Application No.: 10/849,889 Attorney Docket No. 21763.00

IN THE DRAWINGS

REMARKS

ANNOTATED SHEET SHOWING CHANGES

Fig. 2A

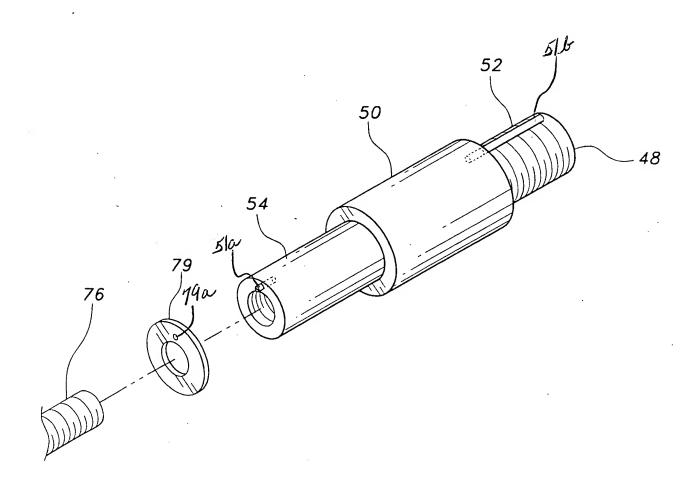
includes Fig. 2A. In Figure 2A, previously omitted references characters – 51a –, –51b –, and –79a –

have been added.

change to Fig. 2A. In Figure 2A, references characters – 51a –, –51b –, and –79a – have been added.

Reference numeral – 51a – designates the pin that protrudes from outer end "54". Reference number

-51b- designates the pen that protrudes from the shoulder of the central portion of shaft "50" and extends

parallel to threaded surface of inner end "52", and reference numeral -79a - points to the aperture defined

in washer "79" that receives pin "51a." The specification has been amended to provide express antecedent
